E/ECE/324
E/ECE/TRANS/505 } Rev.1/Add.21/Rev.3/Amend.3

Addendum 21: Regulation No. 22

Revision 3 - Amendment 3

UNIFORM PROVISIONS CONCERNING THE APPROVAL OF PROTECTIVE HELMETS AND THEIR VISORS FOR DRIVERS AND PASSENGERS OF MOTOR CYCLES AND MOPEDS

Figure 1b: Example of a suitable test apparatus for projections and surface friction (method A)

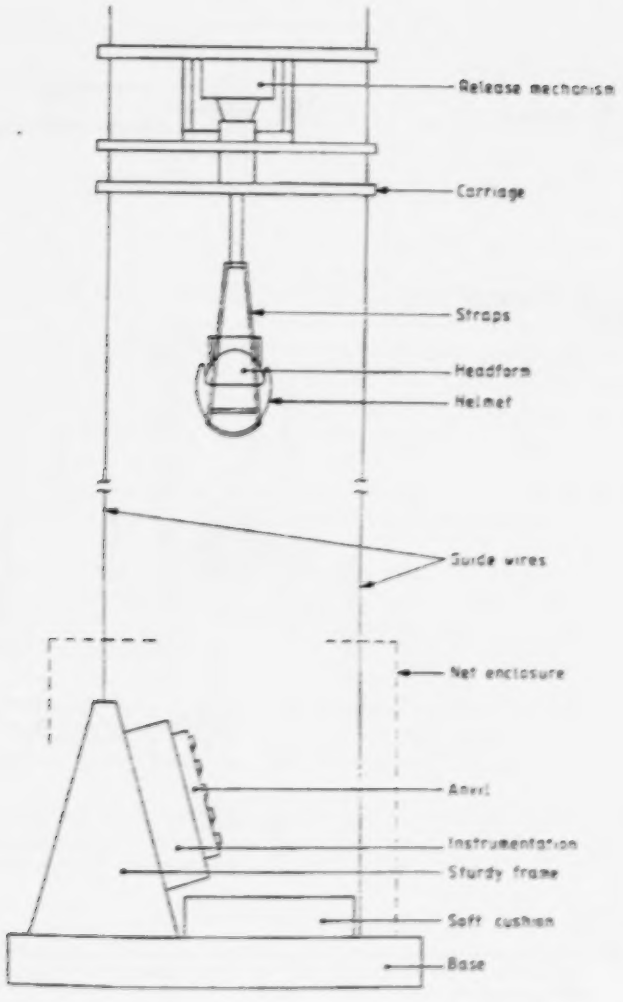
Insert new Figures 1b and 1c, to read:

Figure 3: Arrangement of apparatus for measurement of light diffusion - Method (c)

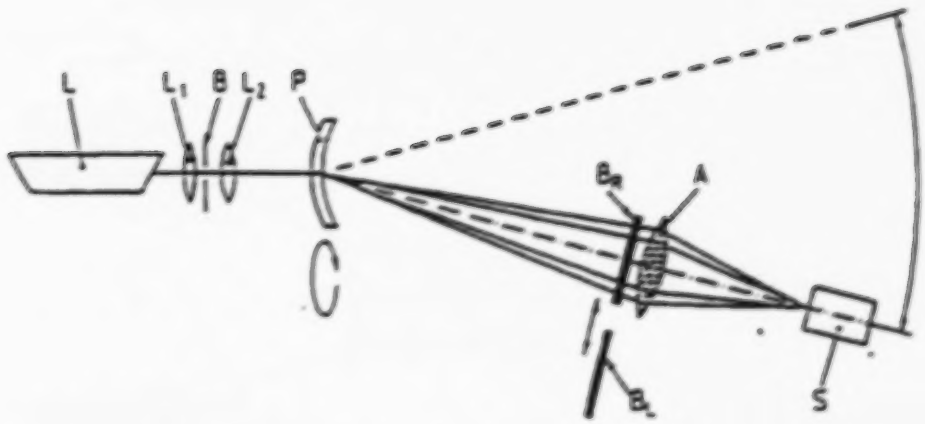
Insert new paragraphs 3. to 3.2.2. and figure 3, to read:

Type approval scheme (Flow chart)

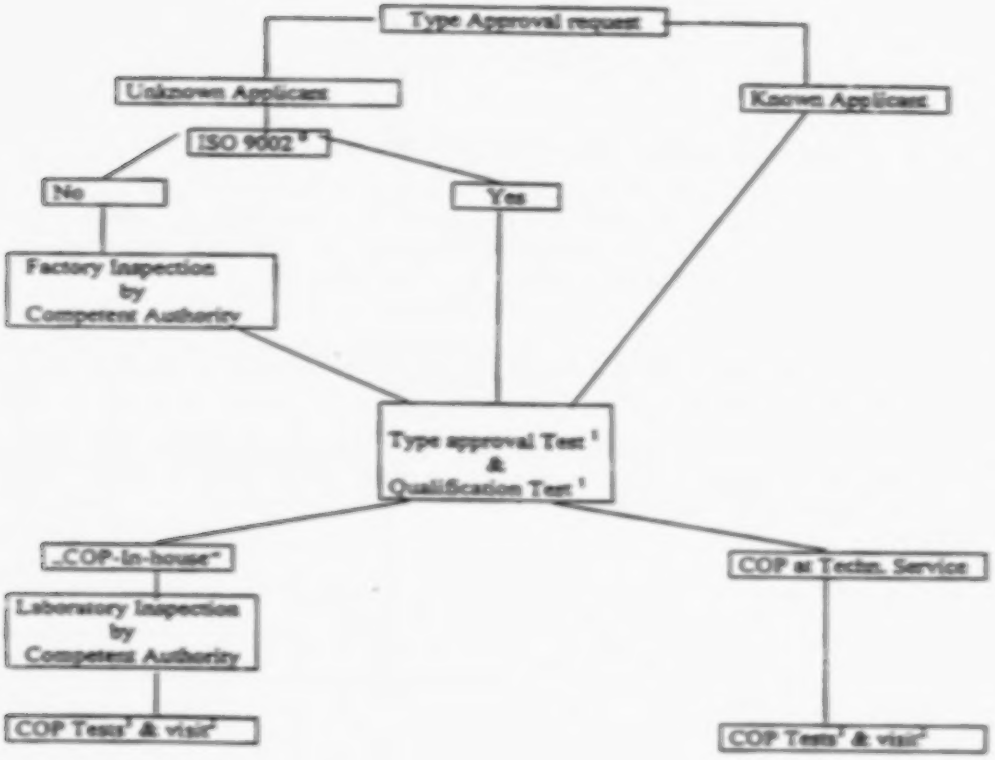
Insert titles of five new annexes, to read:

"Annex 12 - Type approval scheme (Flow chart)

Figure 2: Arrangement apparatus for measurement of prismatic difference

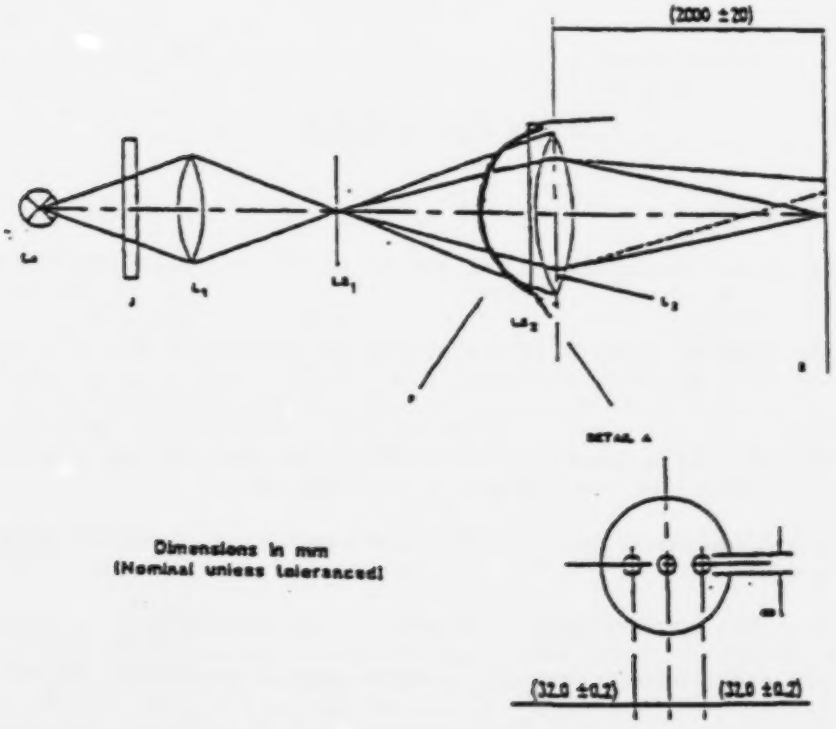
The arrangement of the reference method is shown in figure 2.

Figure 1: Test apparatus for mist-retardant visor"

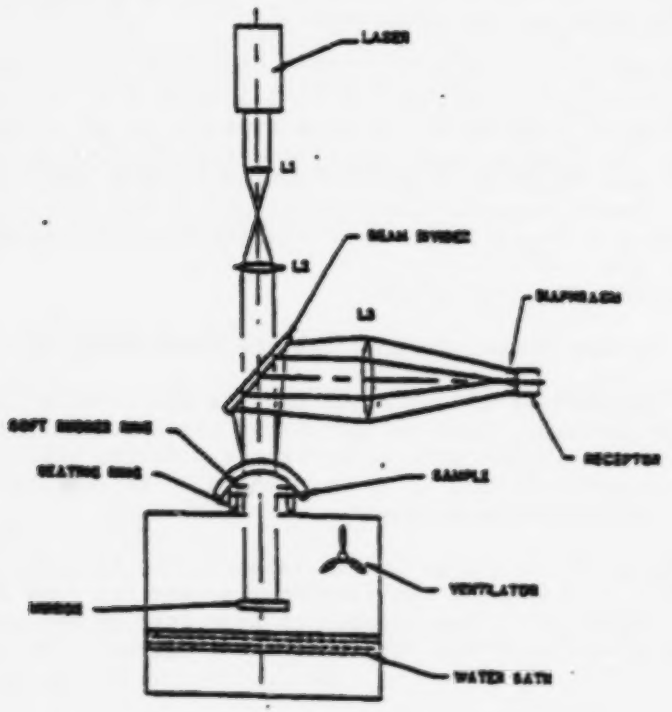
Apparatus to determine the change in the non-diffused transmittance value, as shown in figure 1.
